TITLE: GTA04b7

Date: 03.10.14 23:14

Misc (lower)	
TITLE: GTA04b7	
Document Number:	REV:
Date: 03.10.14 23:14	Sheet: 14/29

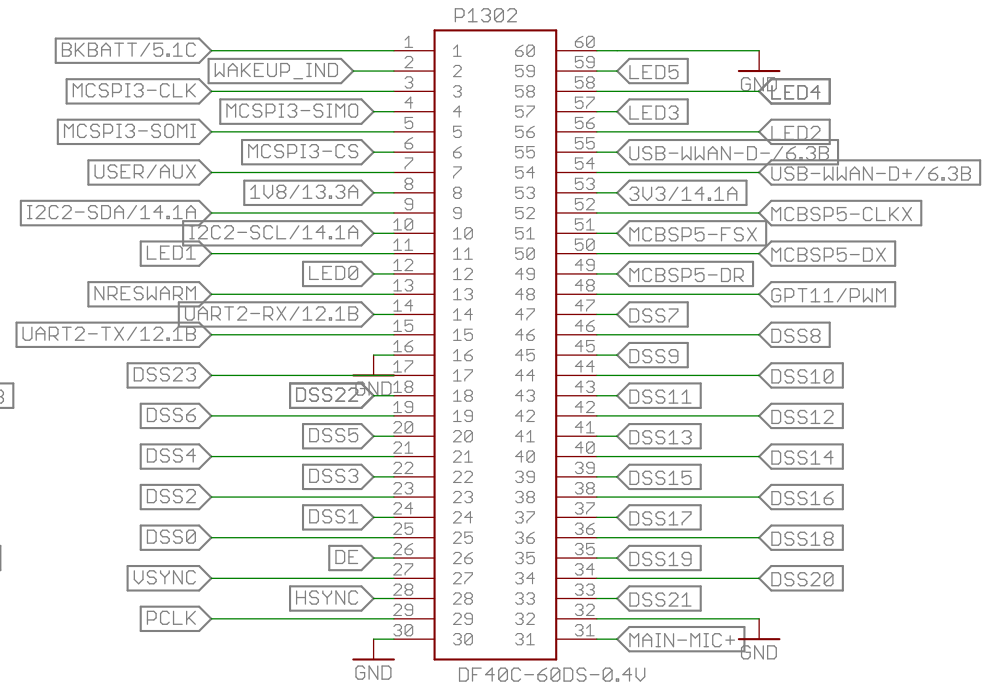
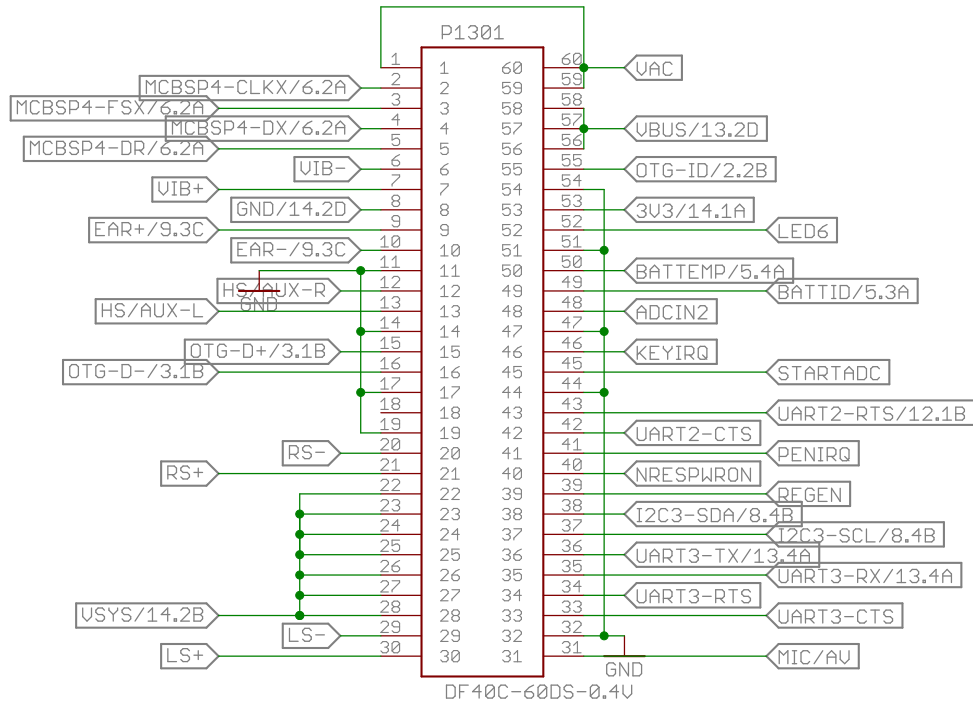
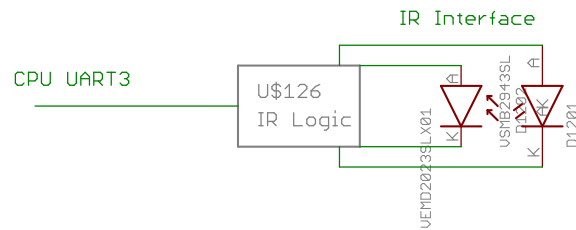
2nd microphone on lower board? Or on bottom of upper?

B2B to upper board

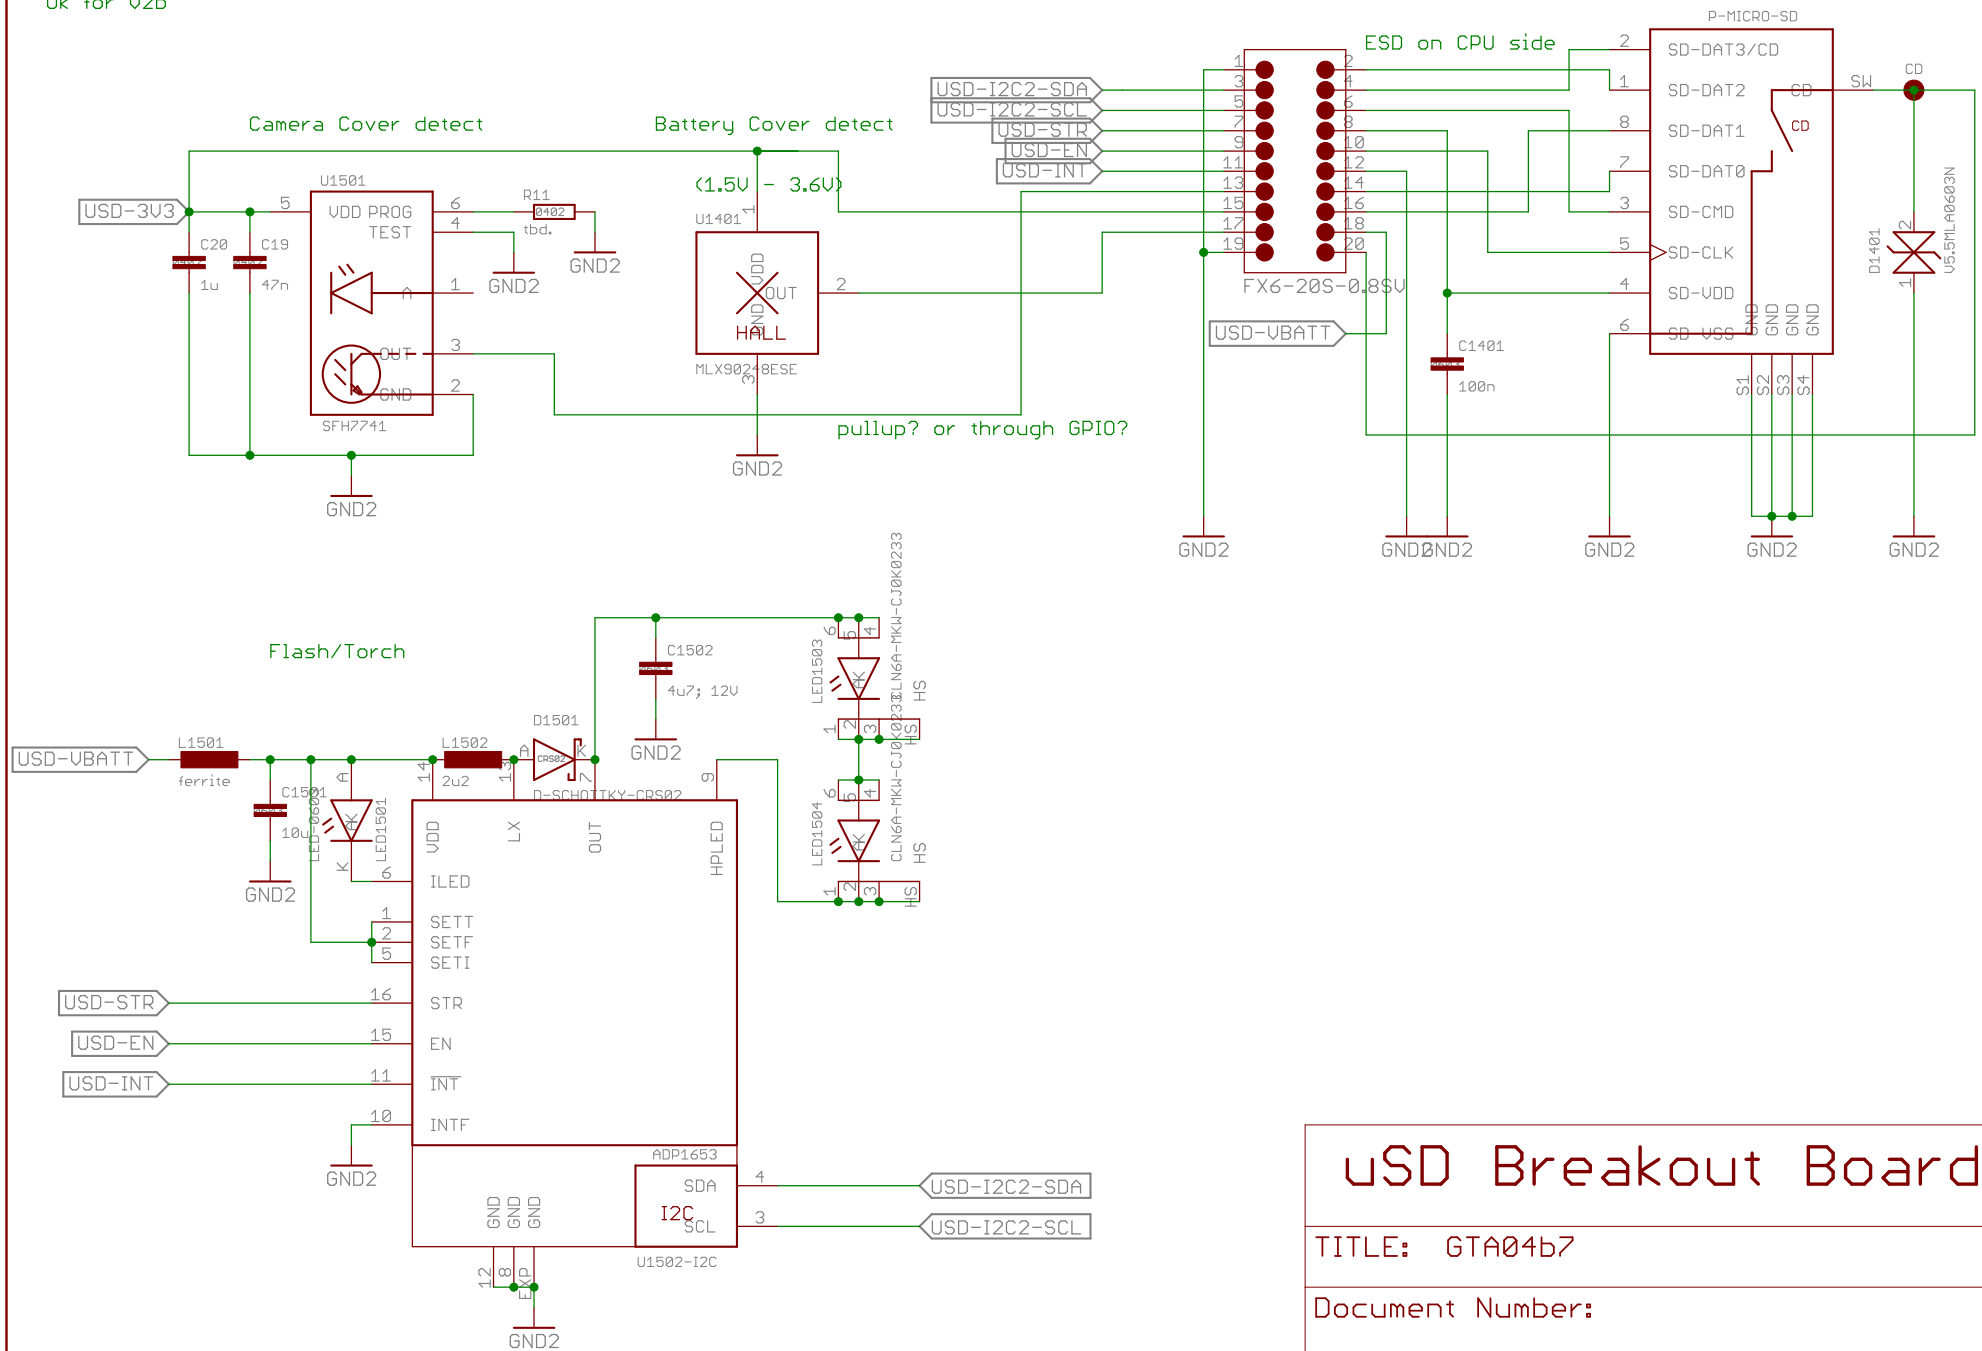
pin assignment tbd. (draft copied from GTA04Custom)

<h1>Keypad</h1>	
TITLE: GTA04b7	
Document Number:	REV:
Date: 03.10.14 23:14	Sheet: 18/29

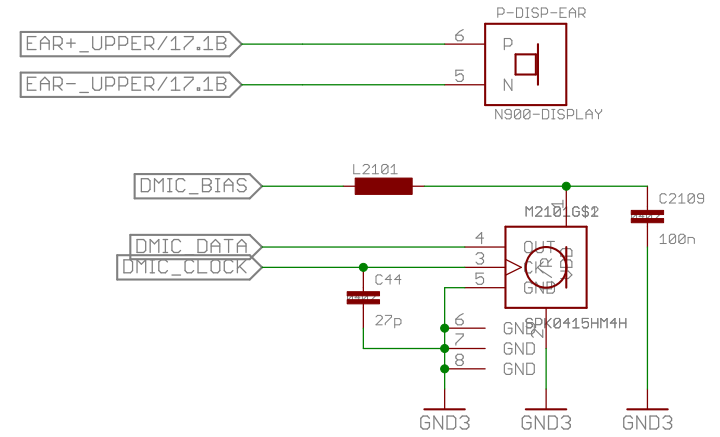
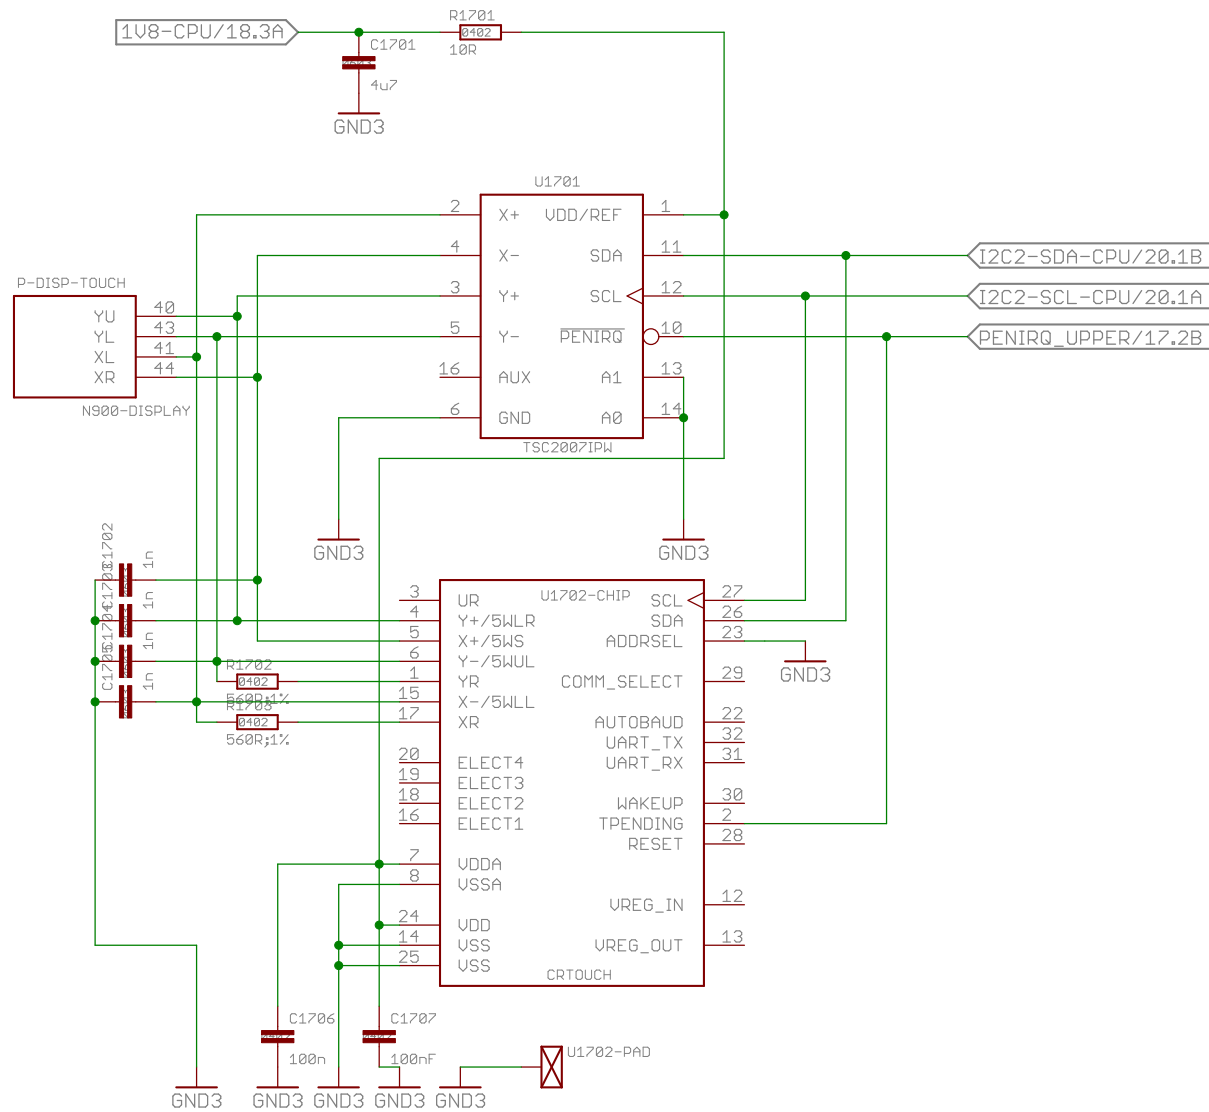
needs final tuning (which button on which position)  
VOL+ and VOL- could drive FETs sitting in the matrix

# CPU + PoP RAM/NAND

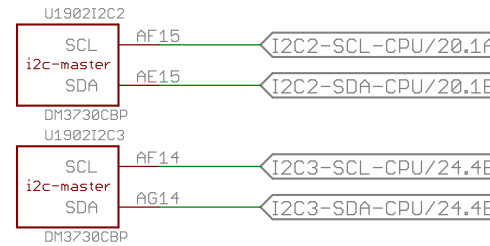
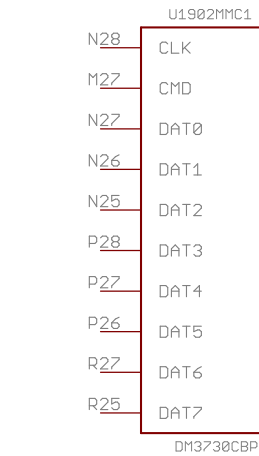
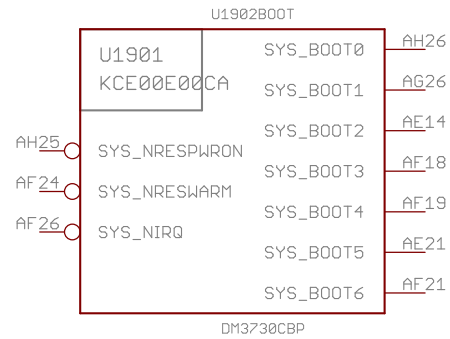
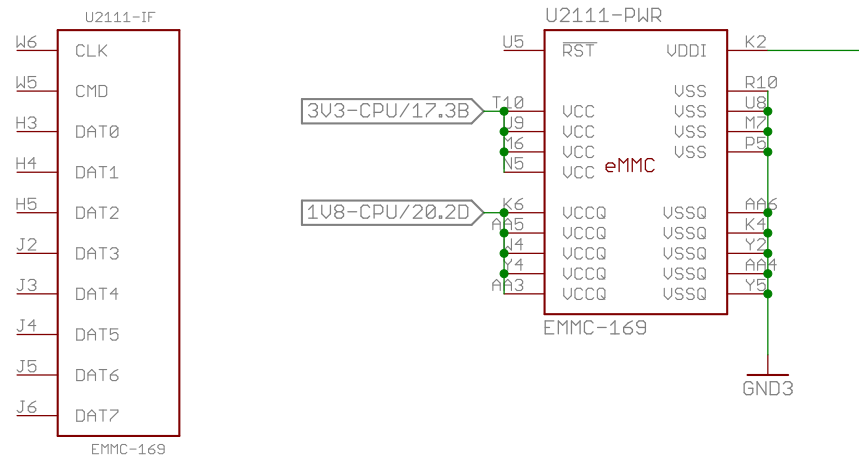
POP or eMMC or both?

<h1>PMU+Codec</h1>	
TITLE: GTA04b7	
Document Number:	REV:
Date: 03.10.14 23:14	Sheet: 23/29

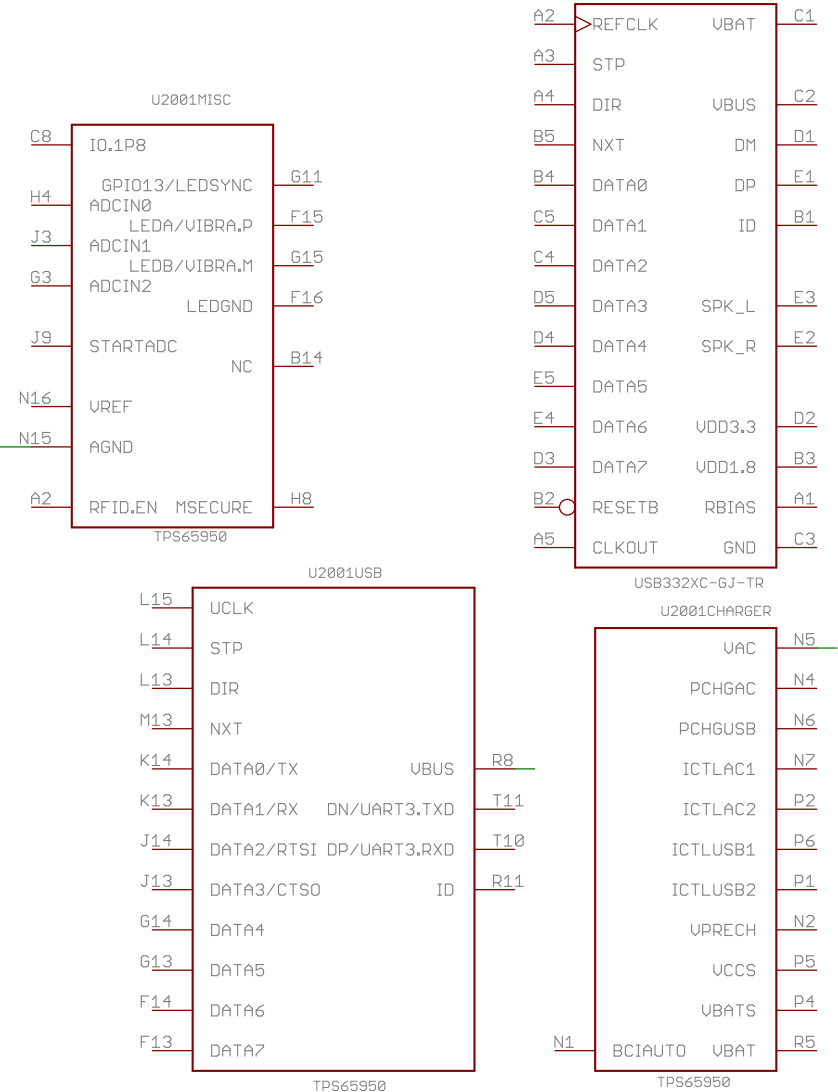
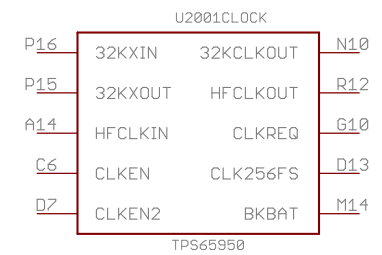
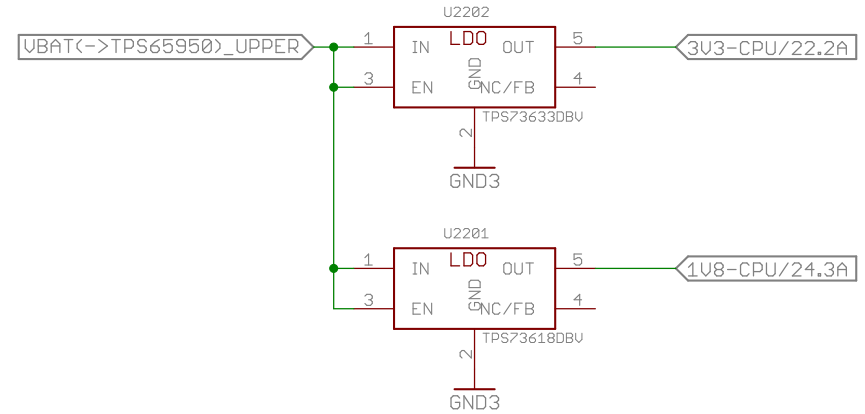
should drive TPS65950

simple capless 400mA LDO for TPS65950 substitute
